Subject: 13 Pacific Road Palm Beach NSW 2107 DA 2020/1136 WRITTEN
SUBMISSION: LETTER OF OBJECTION Submission: Casey

SUBMISSION: CASEY
a written submission by way of objection to DA 2020/1136

Re:
13 Pacific Road Palm Beach NSW 2107
DA 2020/1136

Demolition of existing building and associated structures, construction of a new dwelling

4.3 Height of Buildings:

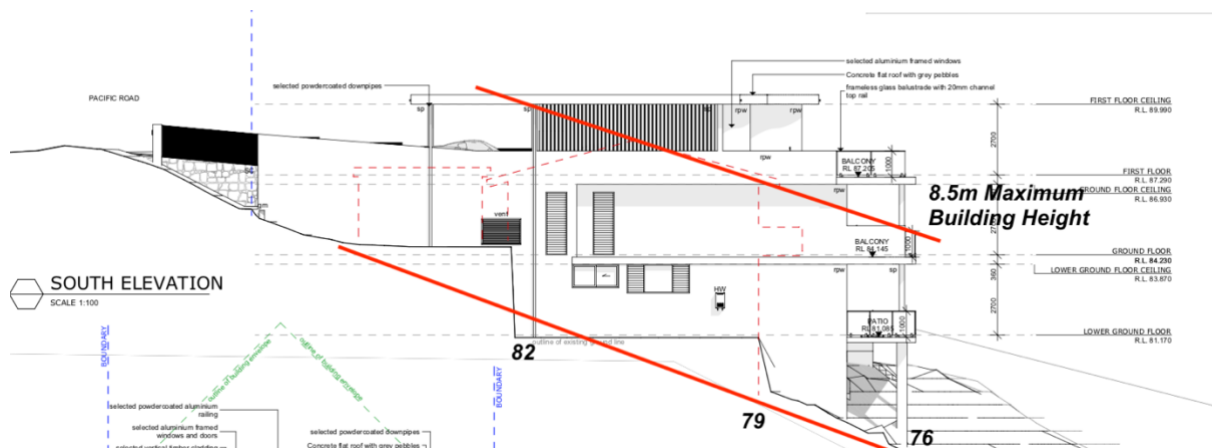
- The south east corner of the proposed first floor shows a proposed balustrade height at RL 88.21. The survey shows the land at RL 76.92. The building height at this location is 11.29m, exceeding controls by 2.79m, a **33% non-compliance**.

- The south east corner of the proposed roof top of gutter shows a proposed height at RL 90.35. The survey shows the land at RL 78.97. The building height at this location is 11.38m, exceeding controls by 2.88m, a **34% non-compliance**.

Unfortunately, all representations of the 8.5m and 10.0m maximum building height both in section and in axonometric on the Applicants drawings are hopelessly false and misleading.

The ground level [existing] levels presented along the southern boundary do not accord with the Applicants Registered Surveyors plan. They are false and misleading.

INCORRECT GROUND LEVEL [EXISTING]

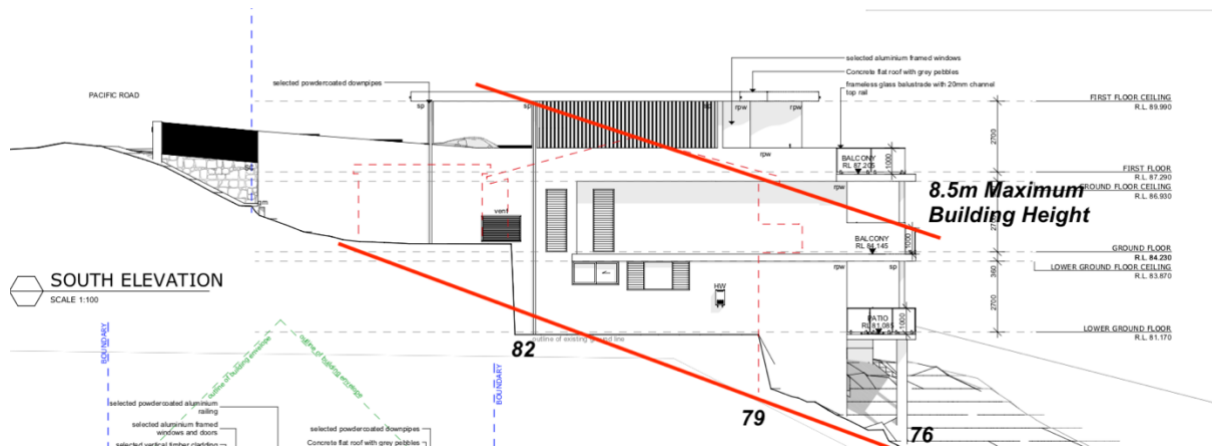
Unfortunately, the Applicant has not represented the ground level [existing] levels as shown on the Applicant's Registered Surveyor's plan along the southern boundary.

The southern elevation does not have any ground level [existing] shown.

It is clear that the *ground level [existing]* proceeds up the southern boundary, along survey marks 75.85, 76.92, 77.44, 78.82, 79.30, 79.98, 80.24, 80.72, 81.88, 81.99, 83.14, 84.41, however the Applicant has not decided to show any of the levels, and has actually shown false and misleading lines to indicate ground level [existing].

At the very least, the Applicant must correct the Southern Elevation, and insert the above levels on the Southern Elevation, and project a 8.5m Building Height control line on the South Elevation.

SOUTH ELEVATION: Proposed Development grossly exceeds controls

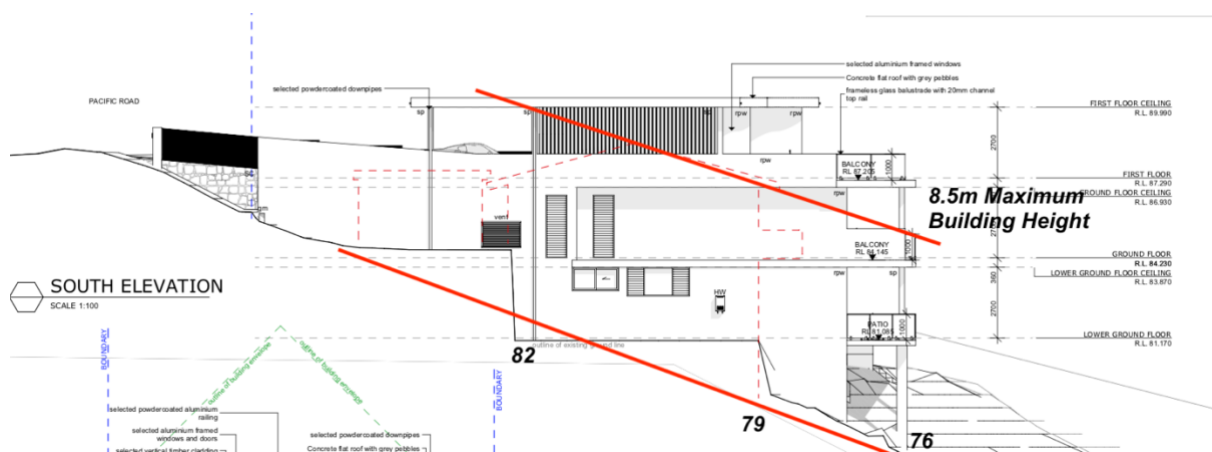
Comment: The height and scale of the proposed development is not consistent with the desired character of the locality, with both neighbours dwelling maintaining strict compliance with the 8.5m development standard.

- The height of the building is in excess of 8.5m, and rises to 11.38m
- There are insufficient environmental planning grounds to justify contravening the height of buildings development standard nor has it been established as reasonable or unnecessary;
- The assessment does not agree with the applicant's statement that excavation is limited and is an appropriate response to the topography of the site. The assessment finds that the proposal involves excessive cut and fill which is not appropriate for the site or its surrounds;
- The bulk and scale of the proposed development is out of character with the area;
- The proposed development would result in adverse amenity impacts for the surrounding area;
- The proposed development results in a dominance of built form over landscape; and
- The proposal results in view loss for an adjoining property
